THE PORT AUTHORITY OF NY & NJ

ADDENDUM # 1

To prospective Bidder(s) on Bid # 41371 for Hardwood Tunnel Contact Rail Ties

TUNNEL TIMBER TIES

DRAWING NO.
WS 061

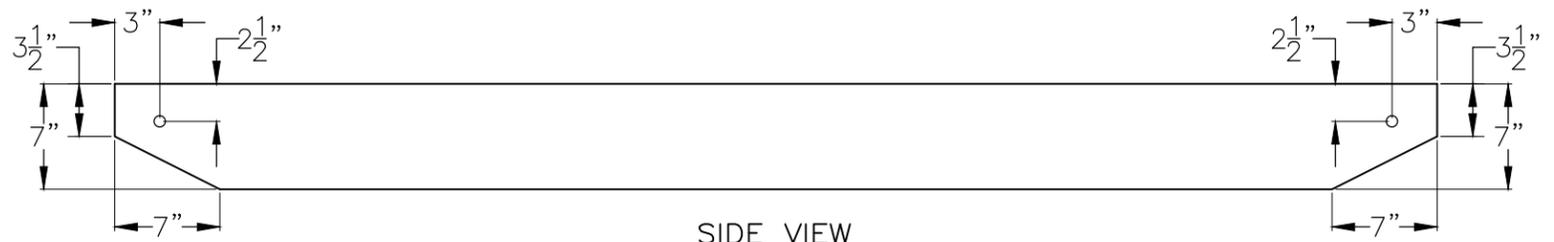
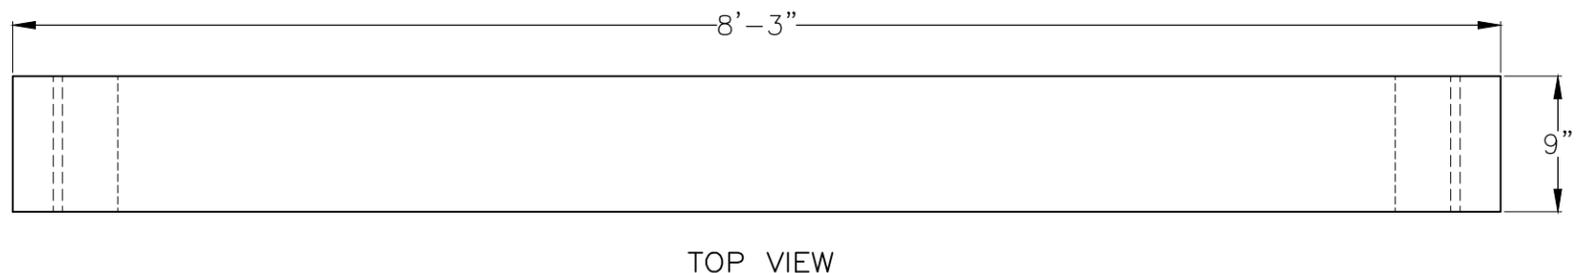
3. The drawing originally issued with the bid incorrect. The revised drawing, with revision date February 6, 2015, has been attached to this addendum.

Question #1	I don't see a MBE/WBE price preference in the bid document. Please confirm that the price preference applies.
Answer #1	For this procurement, the price preference is applicable and the language has been added as per Section I of this addendum.
Question #2	The size of the tunnel ties are larger than what we have supplied in the past. Please confirm the size is 6" x 9" as shown on the bid page and drawing, which does not seem to be consistent with the specifications page.
Answer #2	The RFQ description and the drawing are incorrect. Please see the above new description which changes the size from 6" x 9" x 8',3" to 7" x 9" x 8',3". Additionally, the drawing has been updated and included in this addendum. These ties are longer as they support the 3 rd rail bracket.

NO.	DATE	REVISION
2	02-06-15	REVISED TIE DEPTH DIMENSION
1	07-29-03	RE-ISSUED ON CAD

Hardwood Tunnel Area Contact Rail Ties (7" x 9" x 8', 3")
